DEVELOPMENT REVIEW BOARD  
SUPPLEMENTAL SUBMITTAL

PROJECT NO. 2020-004024

Application No. SD-2021-00029

**DESCRIPTION:** Revised Preliminary Plat, Revised Infrastructure list, proof of resent notifications to Neighborhood

**This Sheet Shows Post-Plat Easements, New and Eliminated Tract Lines and Existing Underground Utility Lines**

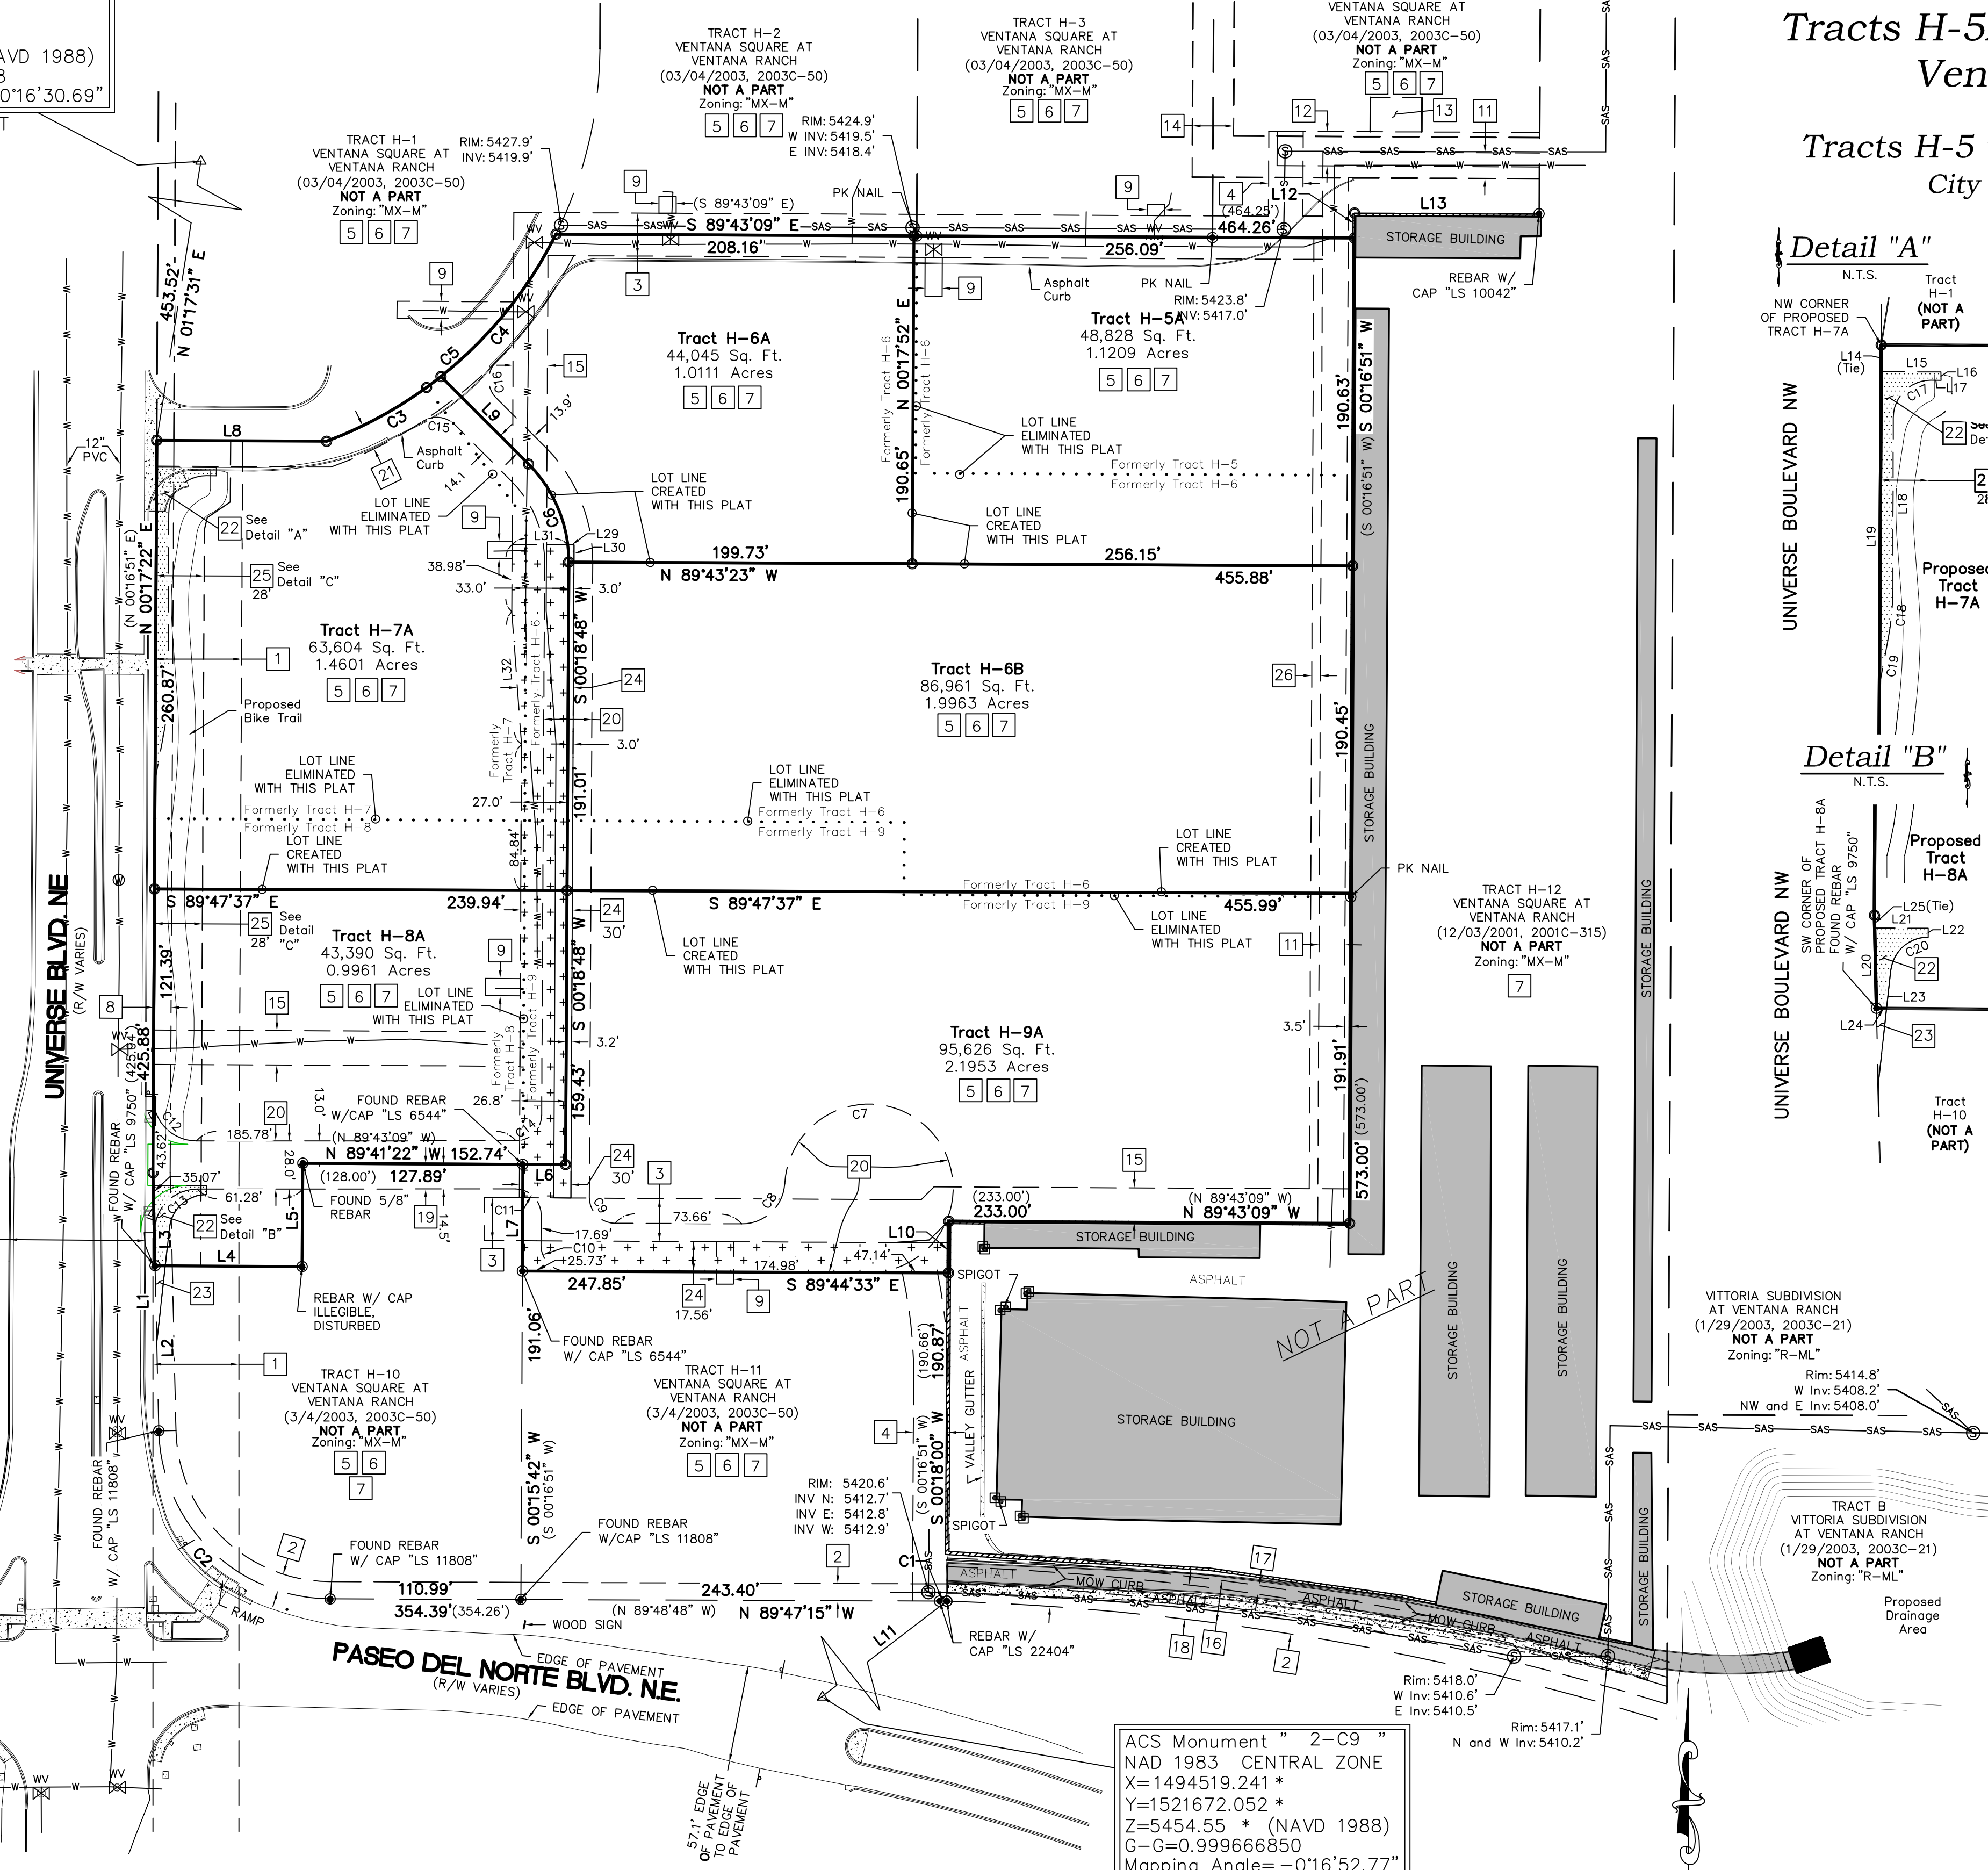
5. Place new access ways onto the infrastructure list along with information on location from property line and access way width. **Notes, Exhibits and Easements have been provided on sheet 2 of 2 of the Plat. The new deceleration lanes, trail and access ways are on the infrastructure list submitted Friday, March 26 before the noon deadline.**
6. A traffic study recommends roadway improvements. All recommended roadway improvements from the traffic study shall be incorporated onto an infrastructure list prior to DRB platting approval. Right-of-way adjustment may be needed based on roadway additions. **All TIS recommended roadway improvements have been added to the infrastructure list.**
7. Shared access shall be established on the plat between the lots. **Shared access between the lots has been established on the Plat (sheet 2 of 2) via notes 6, 19, 20, 21, 22 and 23.**

- i. Plat shows proposed easement #24 (public waterline and sanitary sewer) as the same hatching as easement #15. Please use a different hatching and call it out in the easement notes. The use of proposed easement #24 and modification to

- ii. existing easement #15 is confusing and needs to be addressed. ***The hatching has been modified for clarification.***
    - iii. A minimum width of 25' easement is required for both water and sanitary sewer. ***This has been modified to 25' on the utility plan.***

VENTANA SQUARE  
 UNIVERSE BLVD  
 DECEL LANE SECTIONS

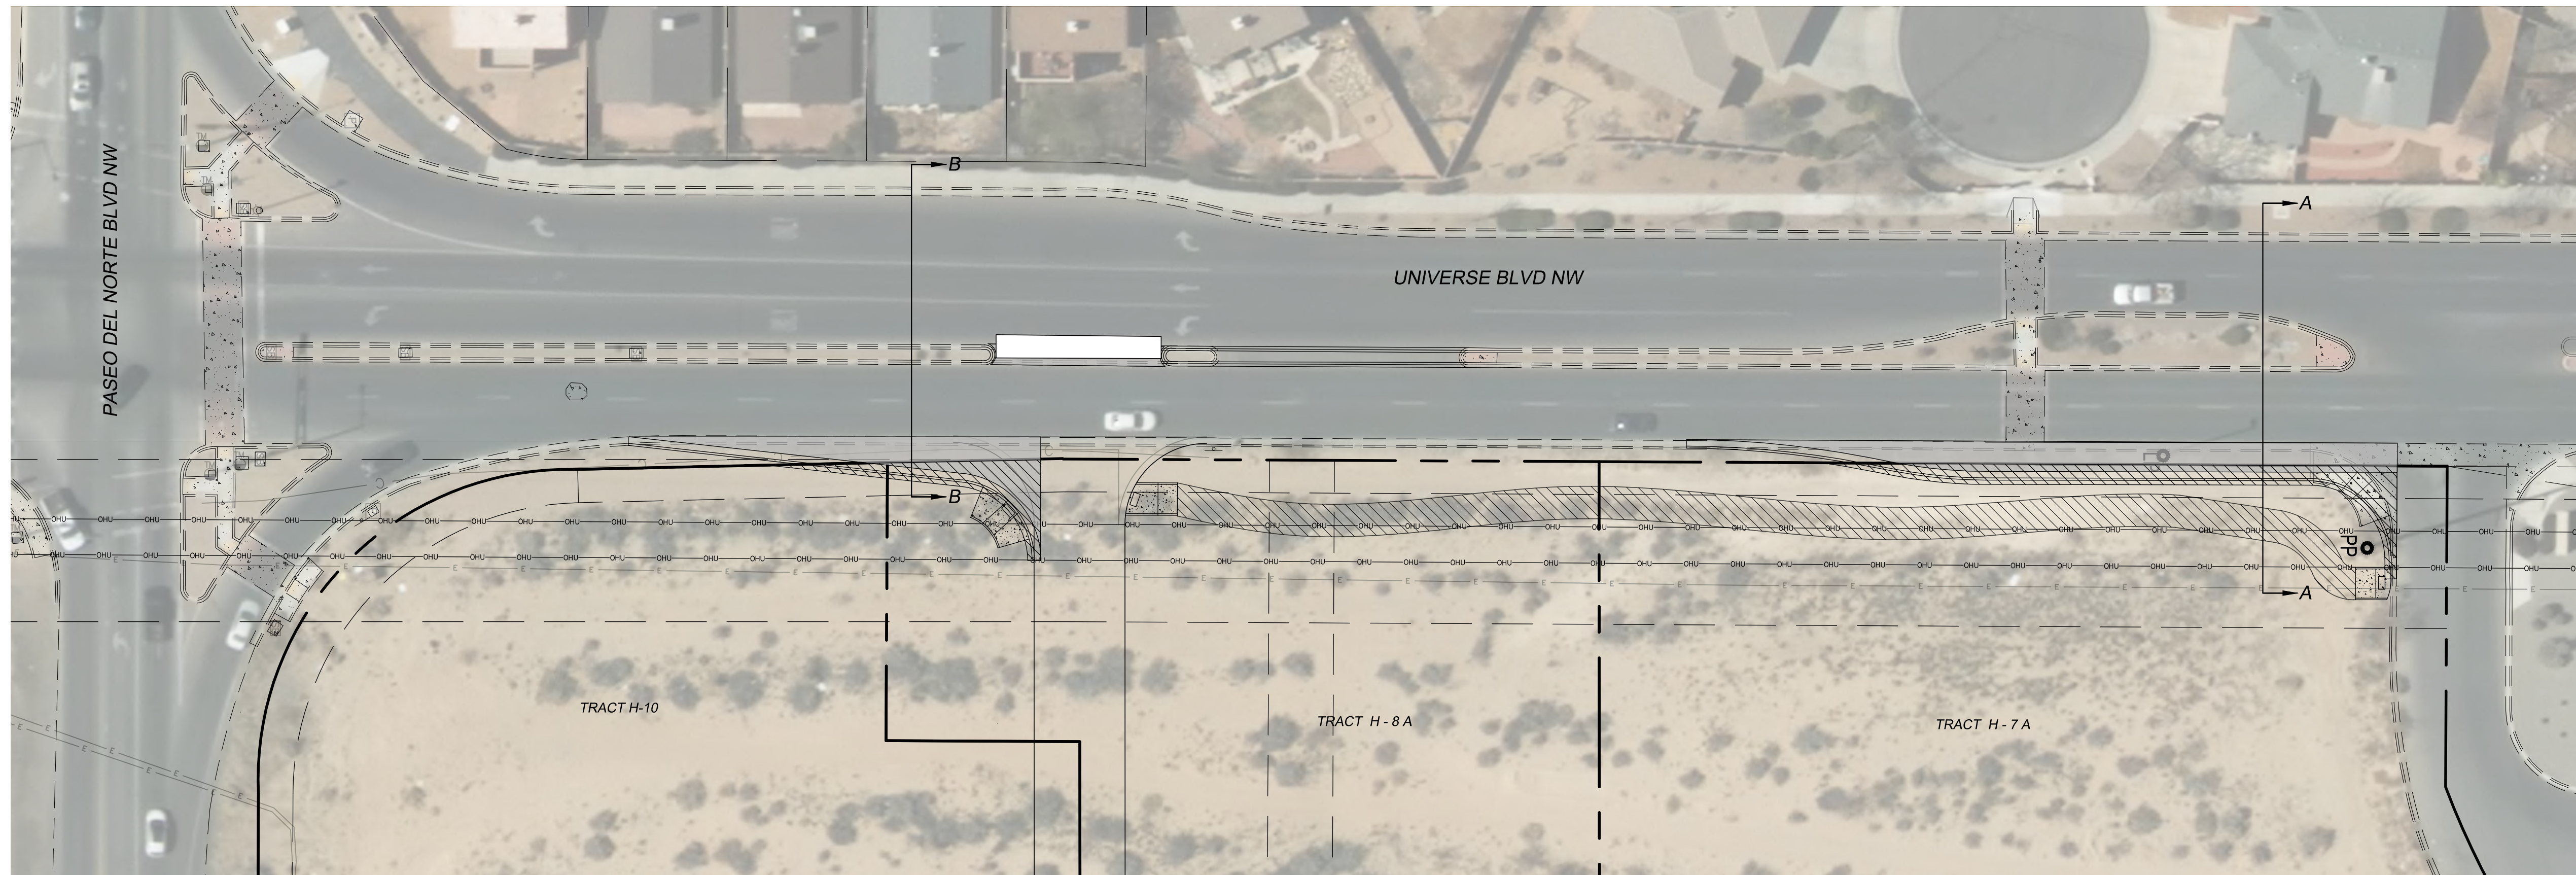
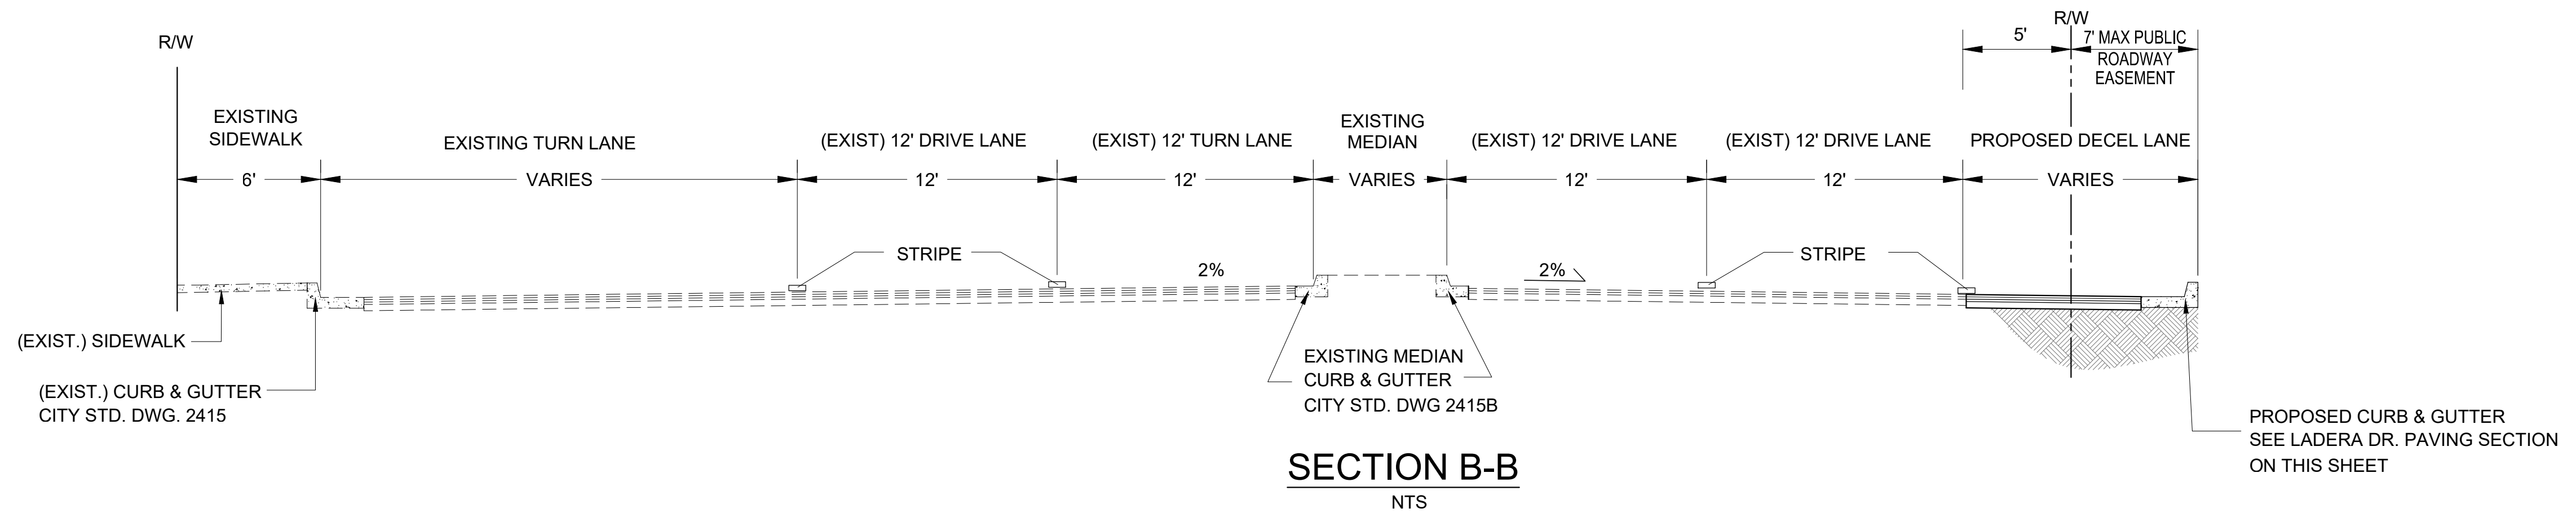
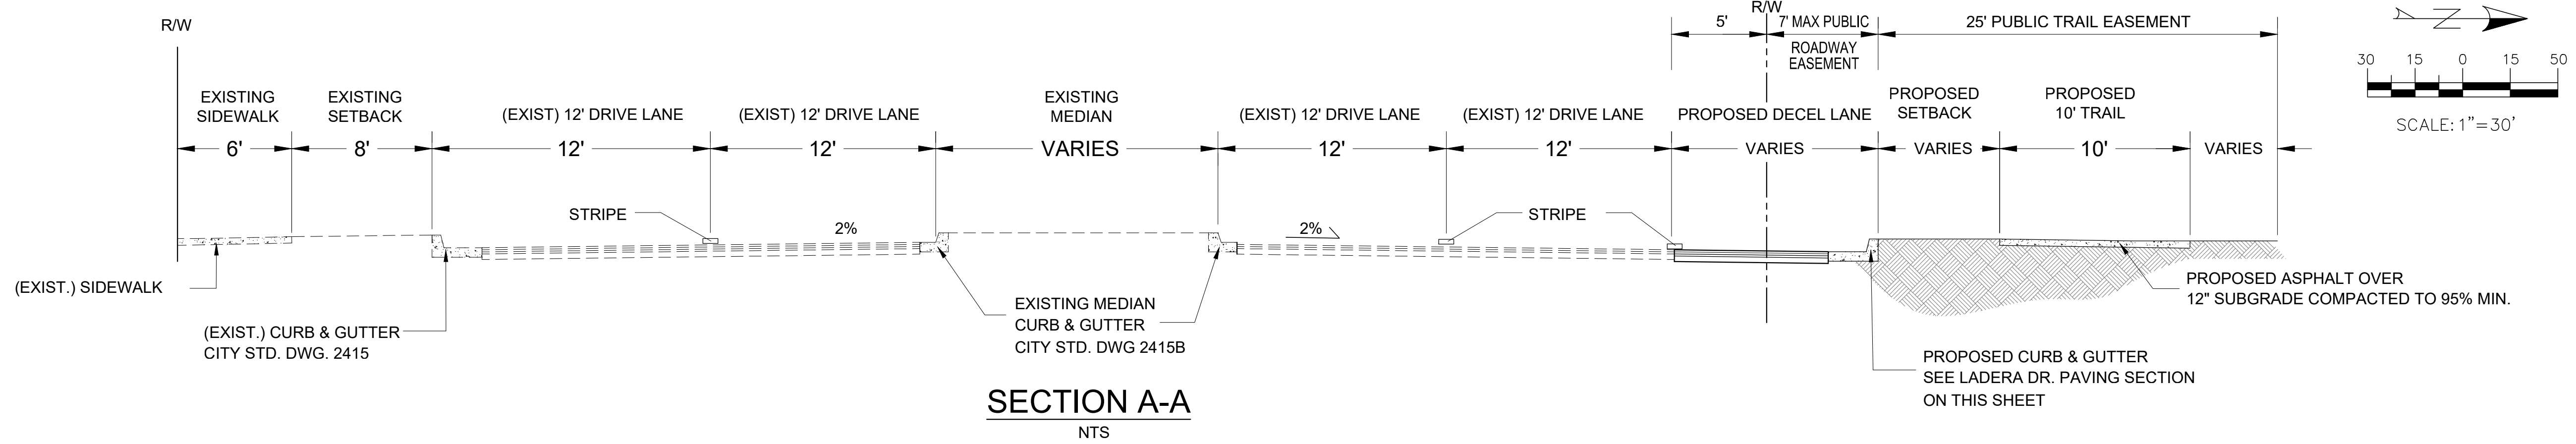
- 1. Place all turn lanes that are recommended from the traffic study onto the infrastructure list, including the lanes off of Paradise Boulevard. – *Per our subsequent Zoom meeting held on Monday, March 15, 2021 we have added the lanes off of Paradise Boulevard onto the Infrastructure List as discussed.***
- 2. For the turning lanes added as part of the infrastructure list, indicate the length of the lane plus transitioning. *This has been added to the infrastructure list.***
- 3. Provide roadway cross-sections for Universe Boulevard based on new improvements along with an exhibit. Right-of-way dedication shall be needed to incorporate the new right-turn lanes to the access ways and the proposed trail. (This is subject to DMD's**
